Scott Horsley
Water Resources Consultant
65 Little River Road • Cotuit, MA 02635 • 508-364-7818

25 October 2021

RE: The Sanctuary, School Street, Manchester-by-the-Sea, MA

Figure 3 - Groundwater Mounding (USGS)

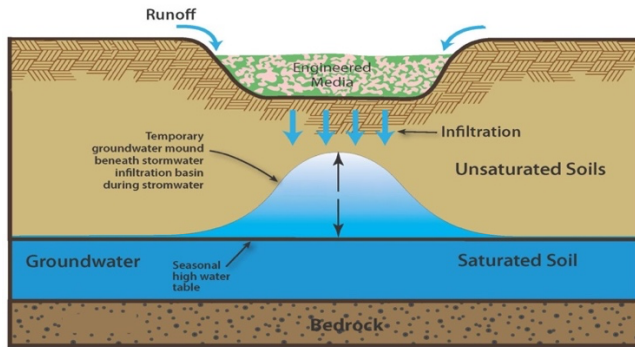
4. The project plans for wastewater management are incomplete. The project plans identify a treatment plant location and two wastewater infiltration areas. However, no details are provided regarding elevations, hydraulic loading rates, wastewater treatment technology, which infiltration area will be used, discharge rates, or effluent water quality. This information must be provided to fully evaluate the impacts of the project on underlying groundwater, surrounding wetlands, streams, and the downgradient drinking water well at Lincoln Street.

The proposed discharge of this volume of wastewater into these glacial till soils with shallow groundwater levels and shallow bedrock raises serious questions about hydraulic impacts including groundwater mounding. A groundwater mounding analysis is required to evaluate these impacts. This analysis should be coordinated and integrated with the groundwater mounding impacts associated with the proposed stormwater infiltration facilities. Both long term (steady state) and short term (precipitation event based) impacts should be evaluated. Maximum high water table elevations should be used as the basis of this analysis.
